**Land Use Petitions:** SLUP-21-0004, CV-21-0002, CV-21-0003, CV-21-0004, & CV-22-0006

**Date of Revised Staff Recommendation Preparation:** April 13, 2022

<b>PROJECT LOCATION:</b>	4435 Hugh Howell Road and 2239 Dillard Street
<b>DISTRICT/LANDLOT(S):</b>	18 <sup>th</sup> District, Land Lot 214
<b>ACREAGE:</b>	±2.33
<b>EXISTING ZONING</b>	DT-2 (Downtown Corridor Zone) and C-1 (Local Commercial)
<b>EXISTING LAND USE</b>	Former Restaurant and <i>existing contractor's office</i>
<b>CURRENT FUTURE LAND USE DESIGNATION:</b>	Downtown and <i>Suburban</i>
<b>OVERLAY DISTRICT:</b>	N/A
<b>APPLICANT:</b>	Chick-fil-A, Inc. c/o Jennifer Santelli
<b>OWNER:</b>	John Poulakis; <i>Scott and Wanda Nelson</i>
<b>PROPOSED DEVELOPMENT:</b>	SLUP to allow a drive-through restaurant with four concurrent variances for inter-parcel access, setbacks, drive-through location, <i>and transitional buffer requirements</i>
<b>STAFF RECOMMENDATION:</b>	<b>APPROVAL with conditions of SLUP-21-0004</b> (restaurant with drive-through) <b>DENIAL of CV-21-0002</b> (drive-through locational requirements) <b>DENIAL of CV-21-0003</b> (setback requirements) <b>APPROVAL of CV-21-0004</b> (inter-parcel access requirements) <b

Revised site plan-submitted April 1, 2022

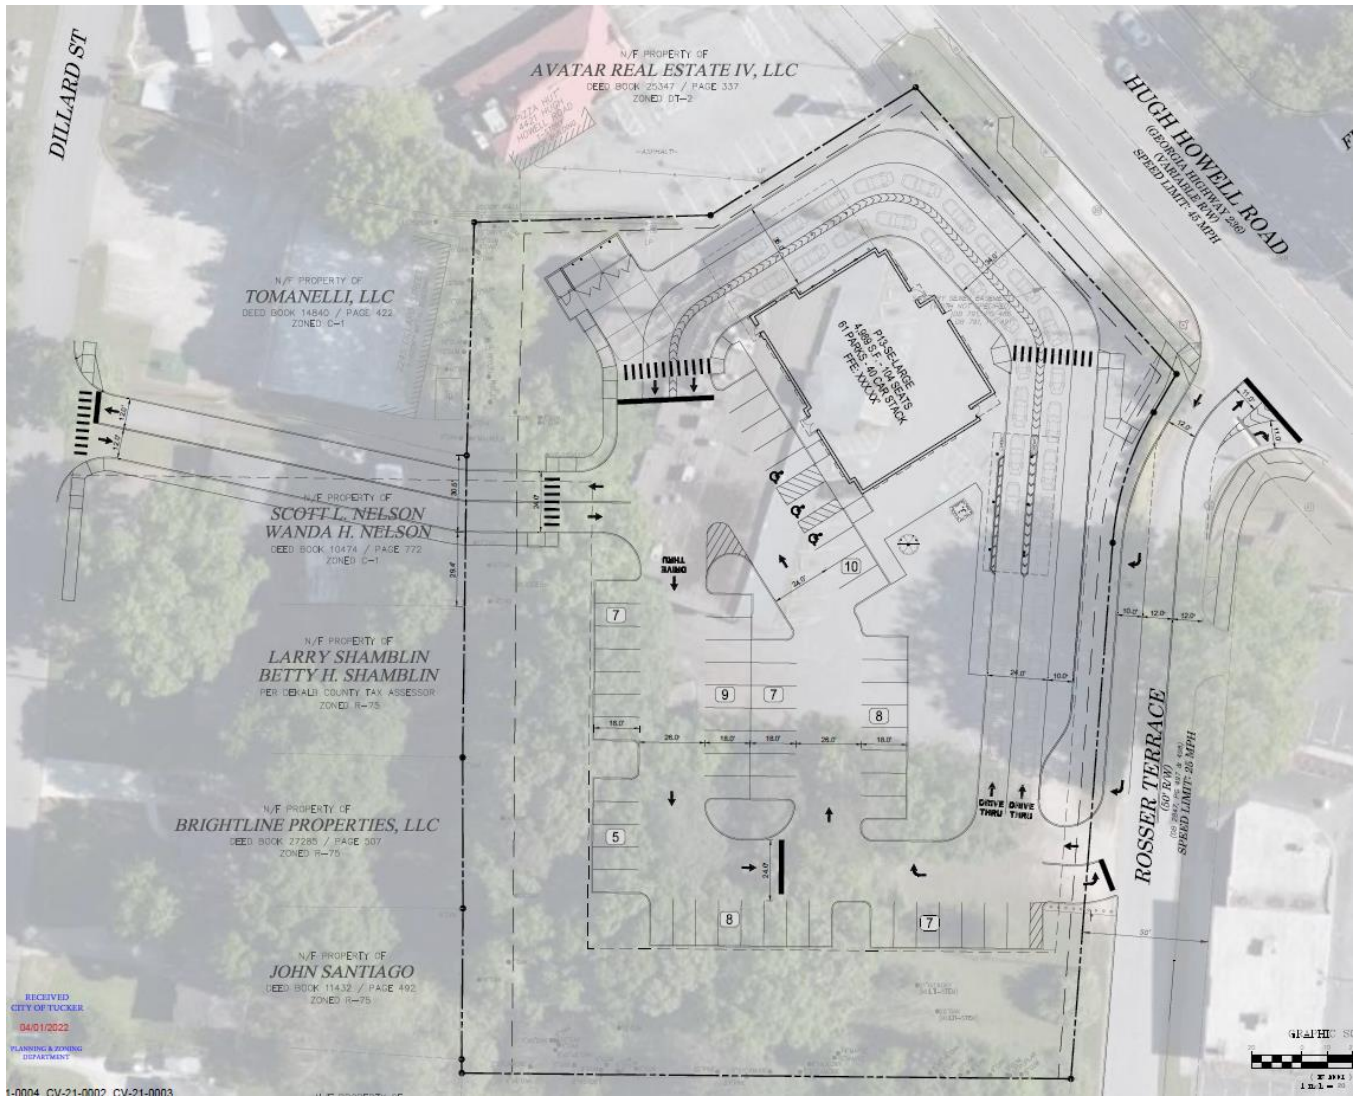
The submitted site plan shows 62 proposed parking spaces, which meets the minimum off-street parking requirements for restaurants with seating for patrons of one space per 250 sq.ft. of floor area. The site plan also allows room for 32 stacking spaces across the two drive-through lanes. The existing Chick-fil-A at 4340 Hugh Howell Road has stacking for 18 vehicles and the existing Chick-fil-A at 4071 Lavista has stacking for 17 spaces. While our code only requires stacking for 10 vehicles, Chick-fil-A generates more traffic than the majority of other drive-through facilities. The peak stacking for Chick-fil-A during COVID has averaged around 20-25 cars. Pre-COVID stacking numbers were closer to 18-20.

The Downtown Tucker Zoning Districts transitional buffer regulations require that any DT district adjoining an RE, RLG, R-100, R-85, R-75, or R-60 district, must have a 50-foot transitional buffer zone. The subject property abuts residentially zoned properties to the south and west and the site plan shows the proposed 50-foot buffers along the property lines will be maintained. *Like the transitional buffer regulations for any DT zoning district adjacent to residentially zoned properties, commercially zoned parcels have similar requirements when adjacent to residential properties. The applicant is requesting a variance (CV-22-0006) to reduce the required 50' transitional buffer to 29', a reduction of 21'. This request is to allow for a full-access drive aisle into the site from Dillard Street as opposed to just an access point from Rosser Terrace.*

The site plan also shows a 6-foot sidewalk and 5-foot landscape strip along Hugh Howell Road, which complies with the regulations in *Section 46-994 Streets and sidewalks* for the Downtown Tucker Zoning Districts. These improvements are not shown along Rosser Terrace but are required by code.

The drive-through lanes being located in front of the building creates a potentially unsafe condition for pedestrians. The site plan illustrates an ADA ramp that gives pedestrians access from the sidewalk on Hugh Howell Road to the building's front entrance. Pedestrians will have to cross three lanes of traffic in order to reach the building.

1. The property should be developed in general conformance with the site plan submitted on *April 1, 2022*, with revisions to meet these conditions.
2. A landscape plan shall be submitted with the Land Disturbance Permit, subject to the review and approval of the Planning and Zoning Director.
